REPORT FOR
**HIDDEN LAKE
SUBDIVISION**

COLEBROOK,
CONNECTICUT

Environmental Review Team Report

Colebrook Inland Wetlands Commission

Site Plan - East Half

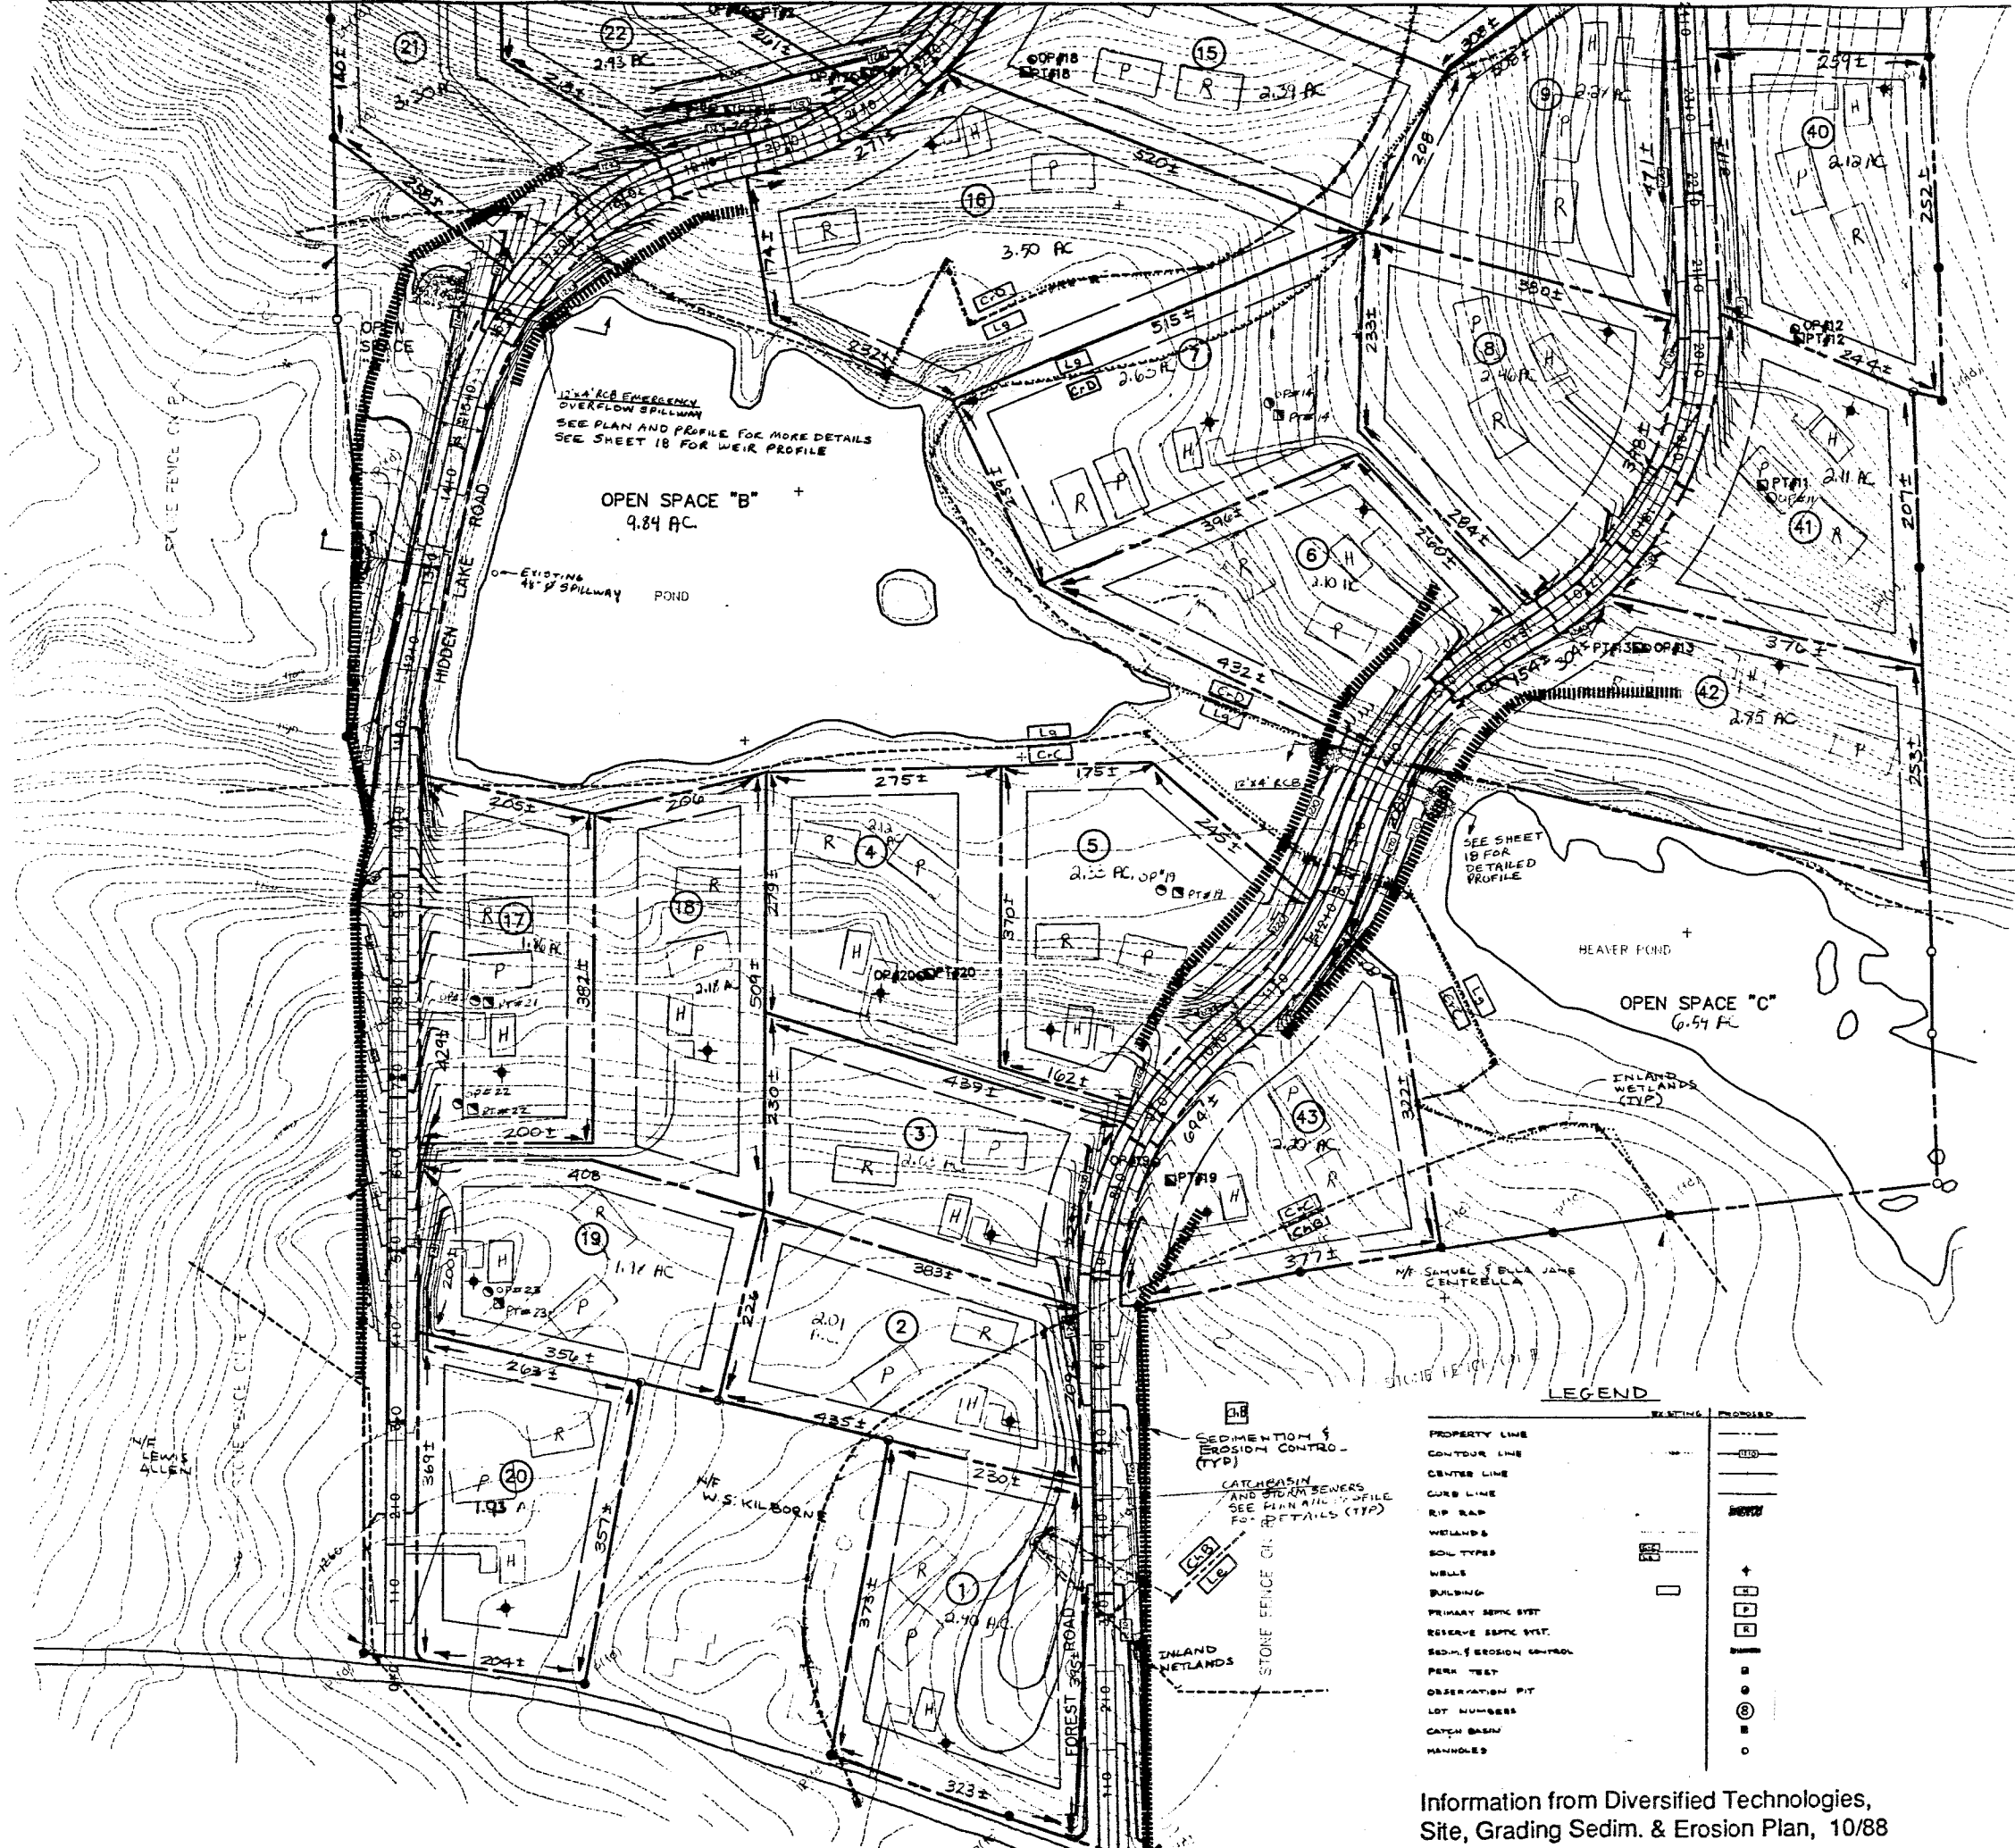
The soil erosion and sediment control plan is basically adequate. Recommendations include using silt fence rather than hay bales, extending E&S controls on Hidden Lake Road, providing silt fence on the south side of Forest Road near the wetlands and including locations for topsoil stock piles, seeding information and person responsible for maintenance on the plans. Maintenance of the E&S controls is extremely important for protecting the wetlands and soil resources.

- d) Provide silt fencing on the south side of the proposed Forest Road from survey station 2+50 to 3+50. This will help prevent sediment from entering the wetlands during road construction.

- 2) Provide construction entrances at the beginning of the proposed Hidden Lake and Forest Roads. These entrances will help to prevent sediment from being tracked onto Pinney Street during road construction.

Watershed Boundary

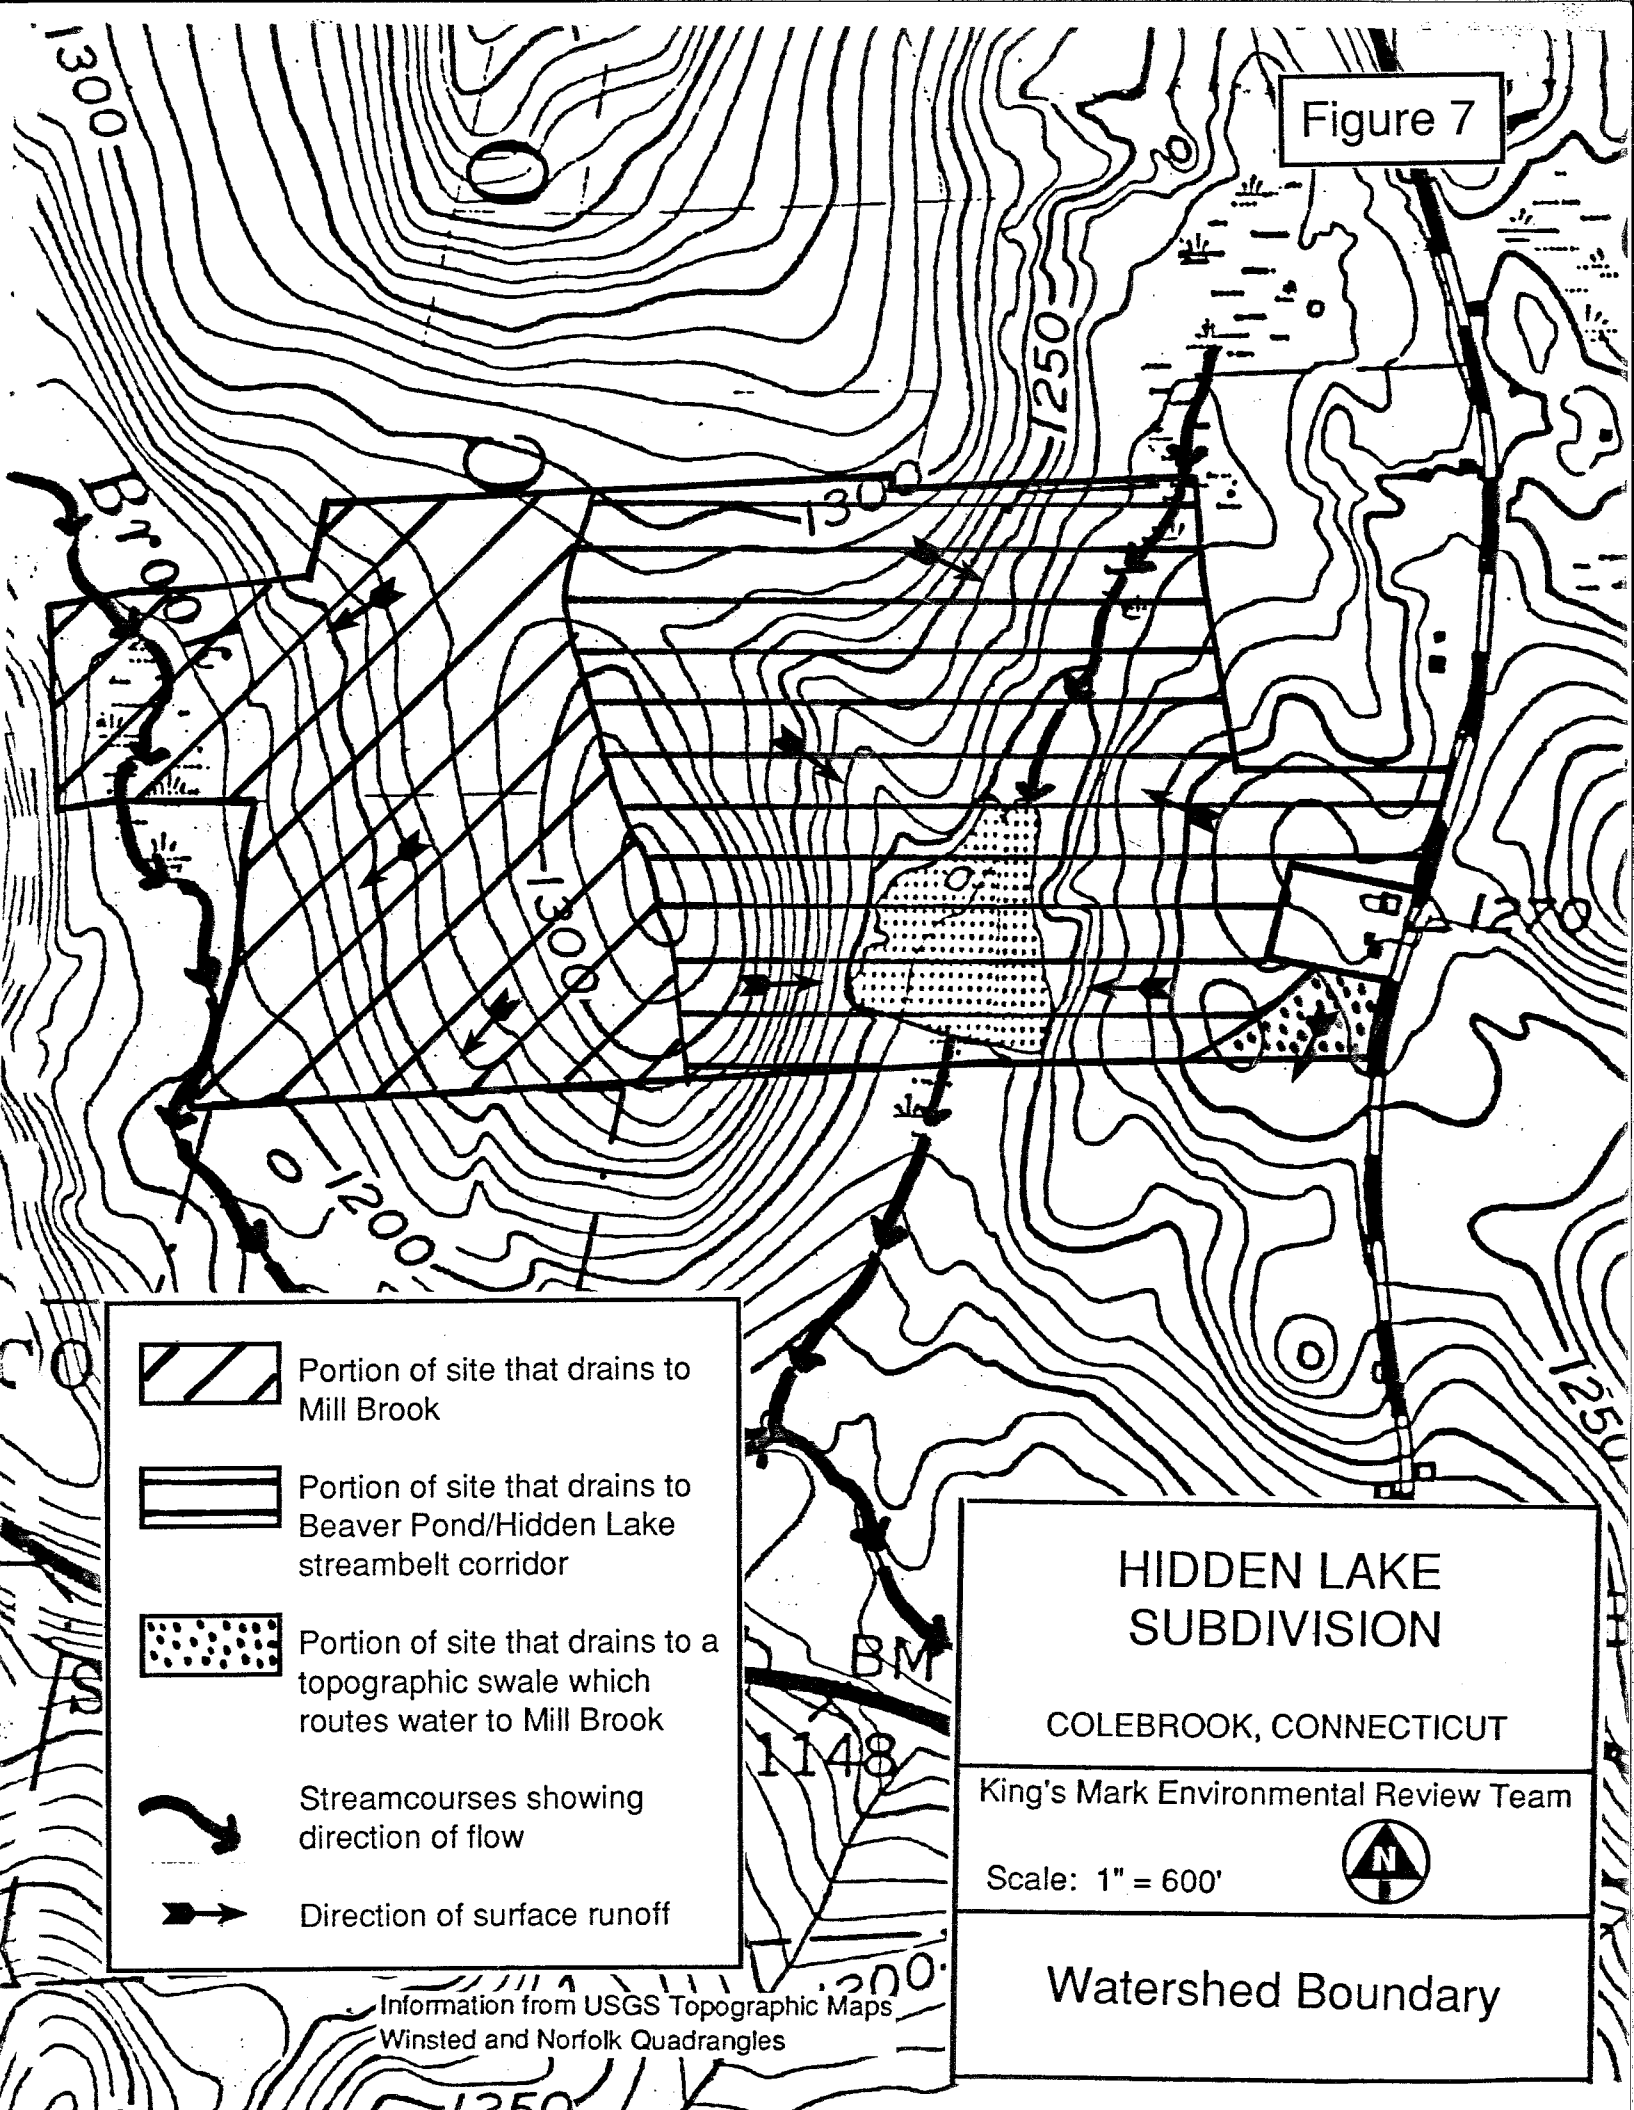
Drainage within the site can be divided nearly in half (see Figure 7). Surface drainage in the western parts drains westward to Mill Brook. At its outflow to Mad River, Mill Brook drains an area of 5.26 square miles or 3366 acres. Most of the land

Development of the site for residential use is expected to increase the amount of runoff shed from the site. The amount of increases will depend upon the extent of the development, the impervious surfaces created and the amount of vegetation removed or preserved. The major concerns with increased runoff are the potential for flooding of downstream areas and streambank erosion. In order to determine the effects of post-development runoff, the applicant's engineer should produce a stormwater management plan including pre- and post-development hydrologic calculations. These calculations have not been provided to date. The applicant's engineer has provided computations for pipe sizes serving the proposed road system, the spillway road crossing and the wetland road crossing between Beaver Pond and Hidden Lake. Once these calculations, an assessment of downstream effects and plans for control of stormwater are completed, they should be submitted to the Town for review. Calculations should be developed using the appropriate method selected from Chapter 9 of the Connecticut Guidelines for Soil Erosion and Sediment Control (1985). Designs for sediment basins and stormwater detention basins must use the criteria and standards found in the Guidelines.

Town officials should receive a report from the project engineer which states initial conditions and storm frequencies to be analyzed. A summary table showing the pre-development, post-development and designed system peak discharge for all design frequencies should also be included.
